Memorandum

Planning and Urban Development Department

To: Stuart O'Brien, Chair and Members of the Portland Planning Board
From: Nell Donaldson, Development Review Services Manager
Date: May 15, 2015
Re: Bishop Street Apartments, 72-78 Bishop Street, Avesta 72 Bishop Street, LP
Project #: 2015-060 **CBL:** 293 C002001
Meeting Date: May 19, 2015

Figure 4: Preliminary site plan and Bishop Street elevation

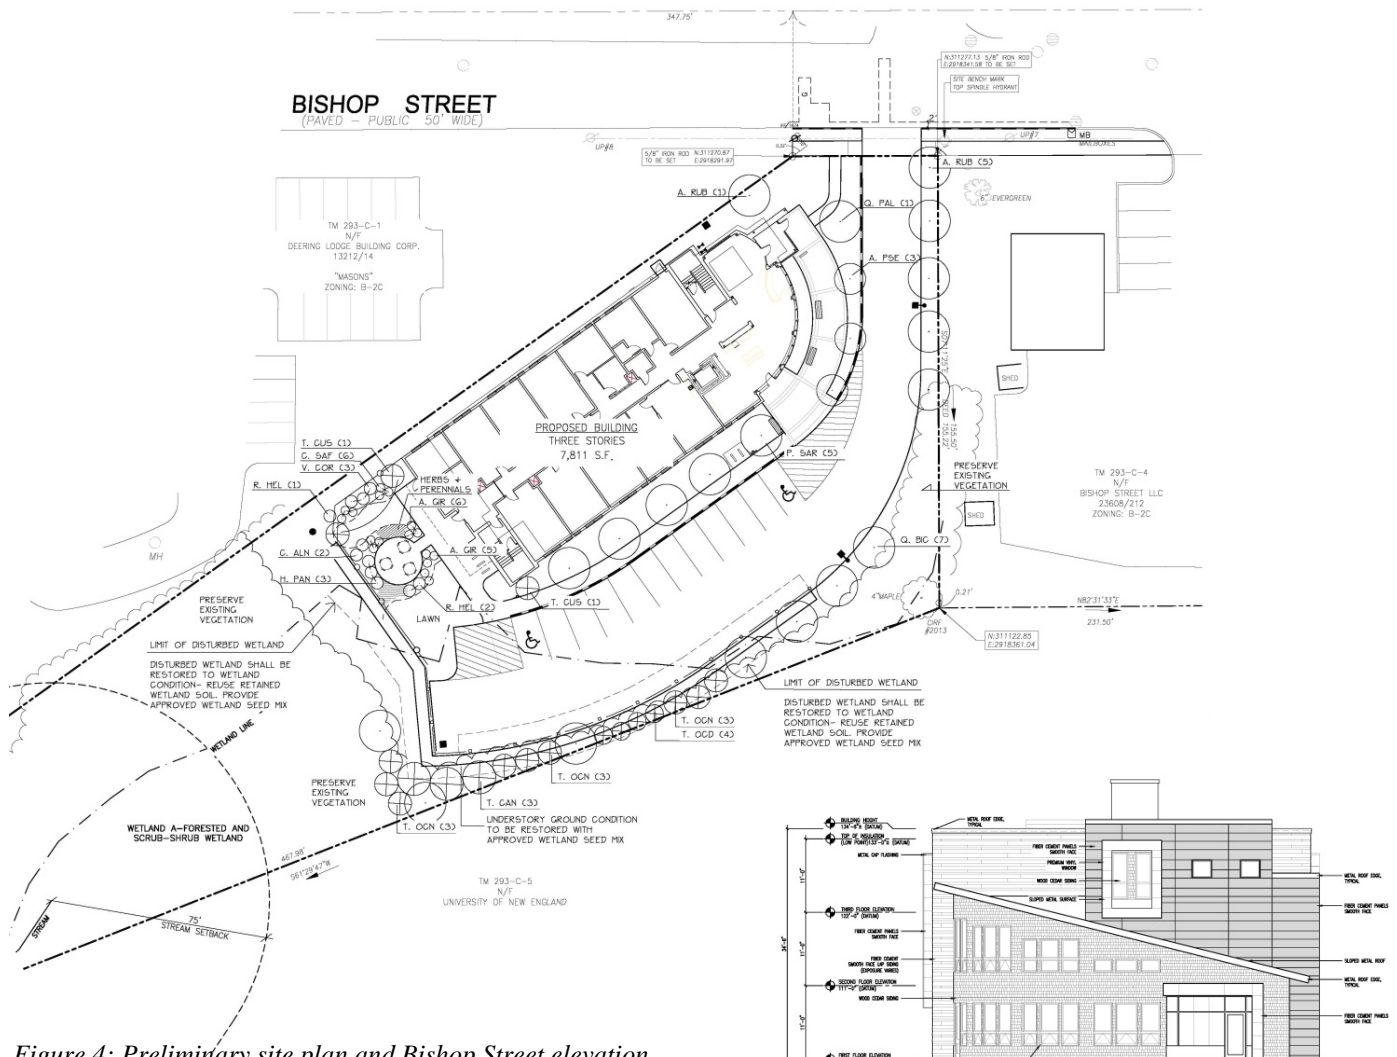
The proposal for the Bishop Street Apartments focuses around the development of a three-story, 30-unit building to house formerly homeless individuals, many with significant medical conditions, much in the same vein as Avesta Housing’s two other Housing First projects, Florence House and Logan Place. The proposal is a direct response to a call from the City Council identifying the need for additional permanent housing for homeless individuals in locations beyond the city’s peninsula. The building’s 30 efficiency units would be constructed with shared library, kitchen, meeting, laundry, and interior and exterior social spaces. The main entrance is proposed via a vestibule off Bishop Street, and the plans include a sidewalk connection in the right-of-way east to Morrill’s Corner. 12 parking spaces are proposed, as is landscaping. Stormwater treatment would also be provided on site (Figure 4).

Figure 5: Bishop Street frontage and setback

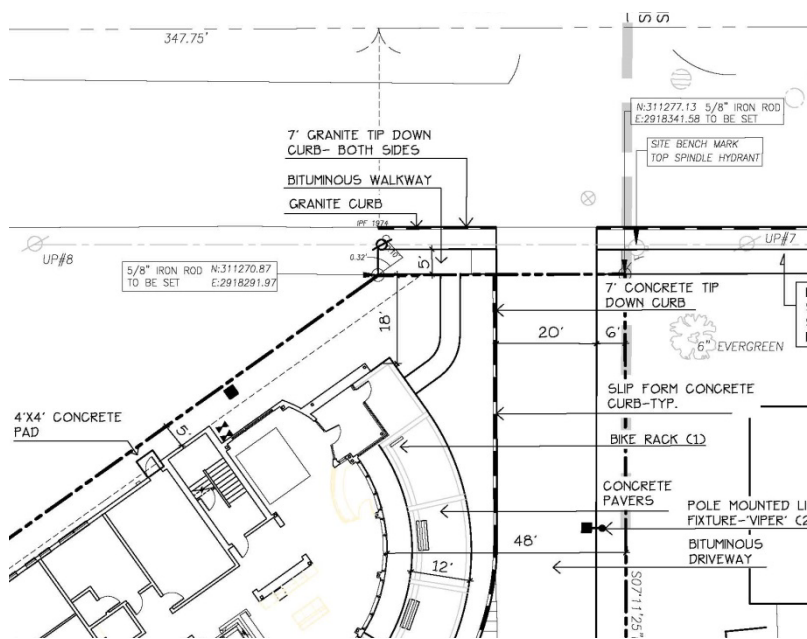
1. *Front Yard Maximum.* The B-2c zone establishes a front yard maximum of 10 feet, which the applicant currently proposes to exceed. At its closest point, the building is planned to sit 18 feet from the property line (*Figure 5*). The ordinance does provide for an exception, stating that “the Planning Board or Planning Authority may approve a different amount for irregularly shaped lots or lots with frontage less than 40 feet provided this standard is met to the maximum extent practicable” (*Section 14-185*). During the review of the zoning map amendment related to this site, as a product of similar discussions regarding active street frontages and the associated density bonuses of the B-2 zone, the applicant argued that, due to the shape of the site and the

need for a driveway entrance, the building could not be located as close to the street as prescribed by the ordinance to qualify as an “active street frontage.” In a continuation of this argument, the applicant has claimed again in their preliminary site plan submittal that 72 Bishop is an irregularly shaped lot and that they have sited the building as close to the street as possible. The applicant writes,

The applicant is requesting that the board approve the project with the proposed deviation from the front yard maximum of the B-2c.

Related to this discussion, the B-2 dimensional requirements also include a provision that, “[w]here setbacks exceed 10 feet, a continuous, attractive, and pedestrian-scaled edge treatment shall be constructed along the street, consisting of street trees spaced at no more than 15 feet on center, approved by City arborist, and a combinations of landscaping no less than 4 feet deep, ornamental brick or stone walls or ornamental fencing” (*Section 14-185*). The plans do not currently provide such a treatment. Assuming that the board is agreeable to the extension in setback, staff has requested that the applicant address this provision in the final site plan submittal.
